TEXAS DEPARTMENT OF TRANSPORTATION

MINOR DESIGN UPDATES UNDER CONSIDERATION FOR FINAL DESIGN

DRAINAGE ACCOMMODATION

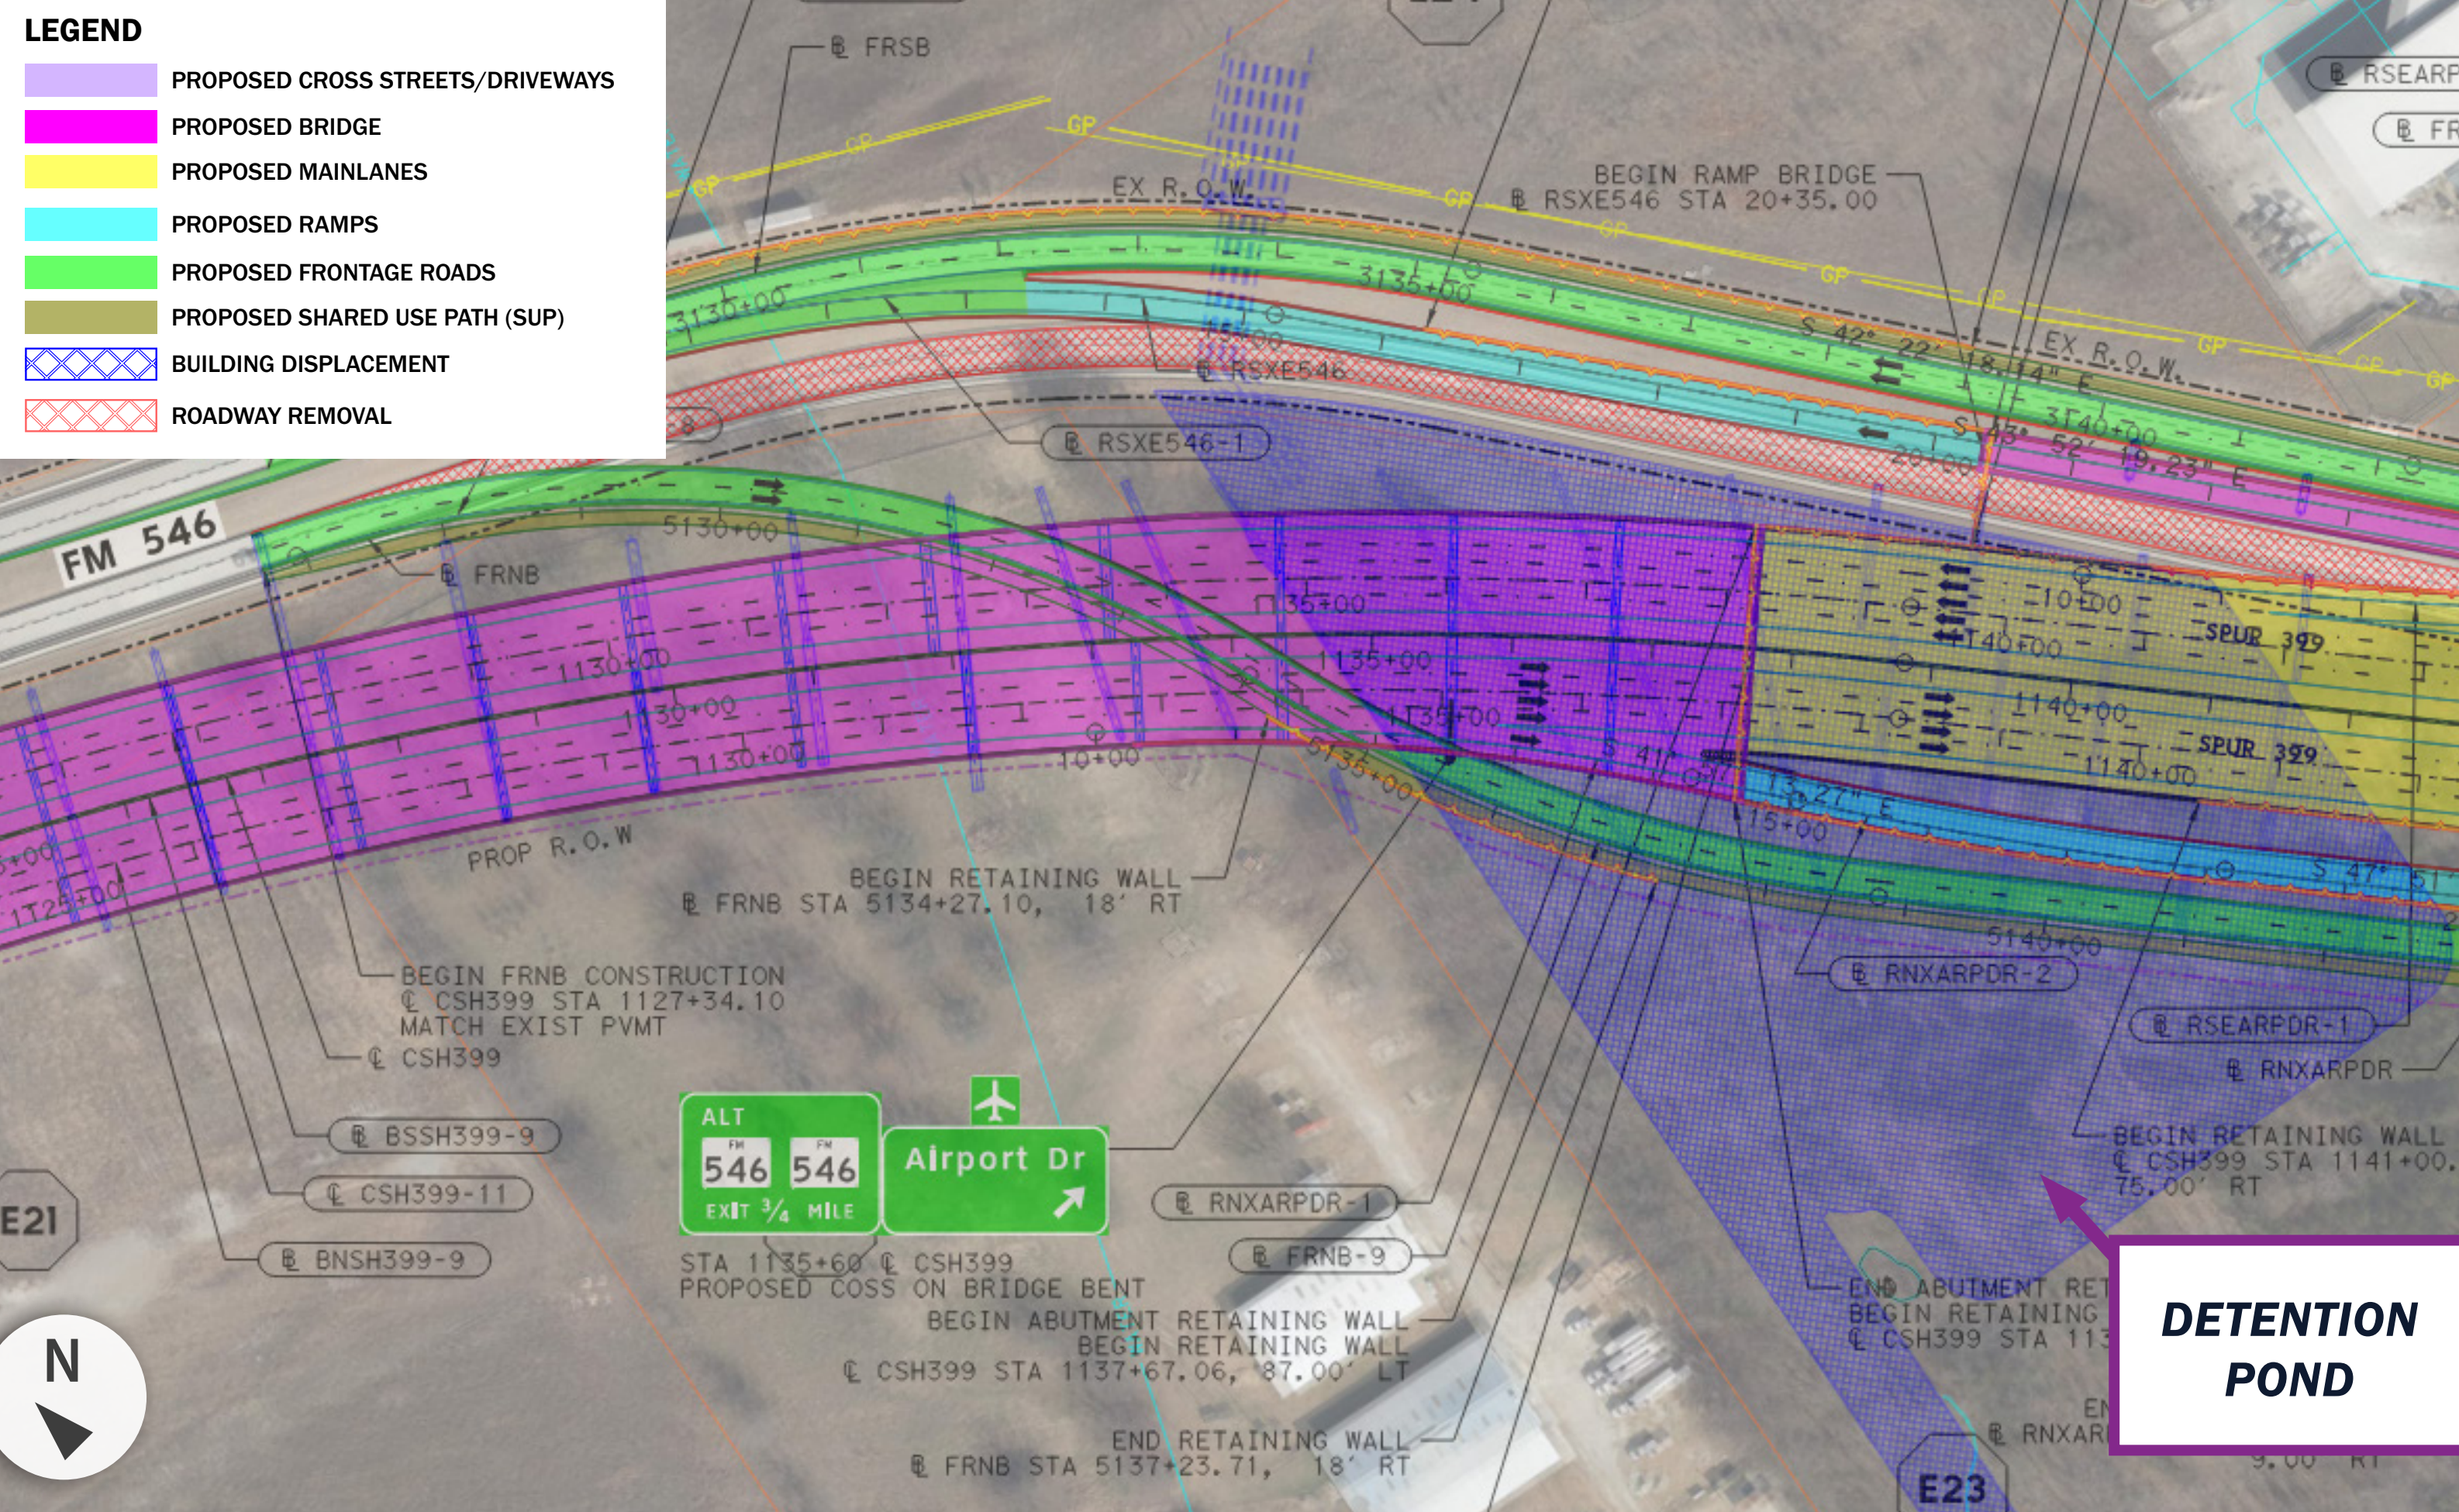
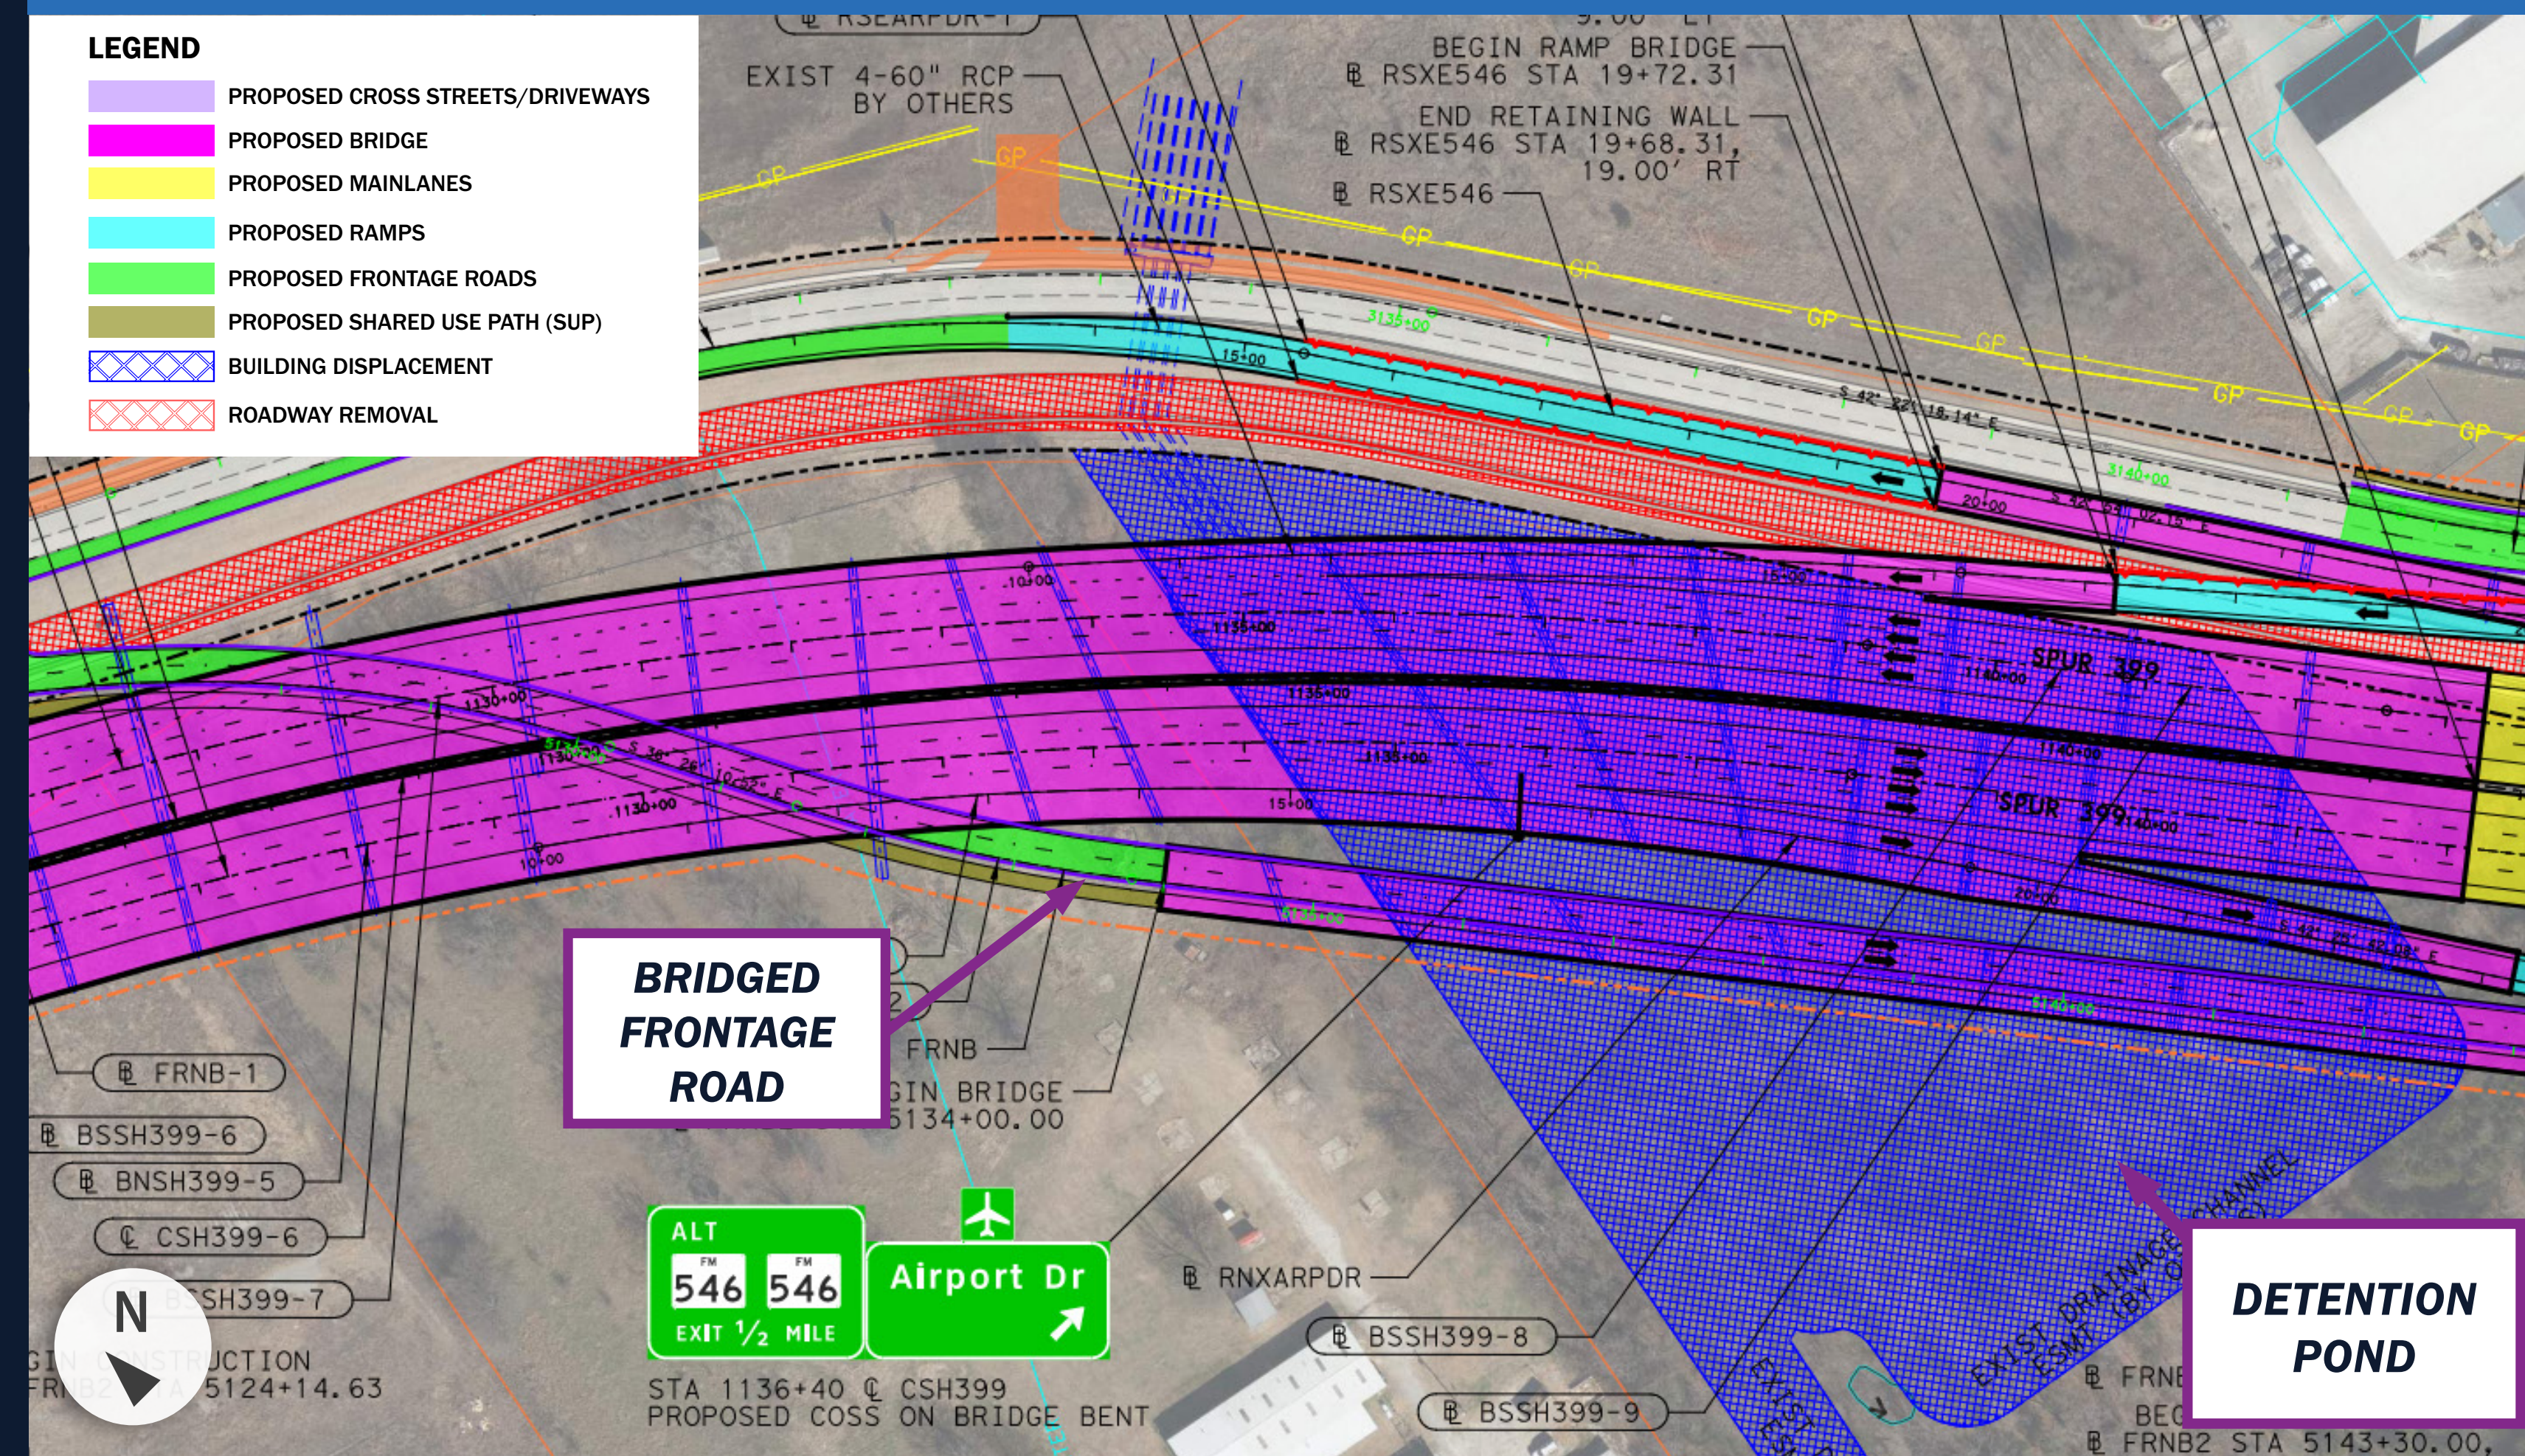
To address the City of McKinney's concerns regarding the McKinney National Culvert Crossing and Detention Pond, the elevated section of freeway was shifted and will now bridge over the pond.
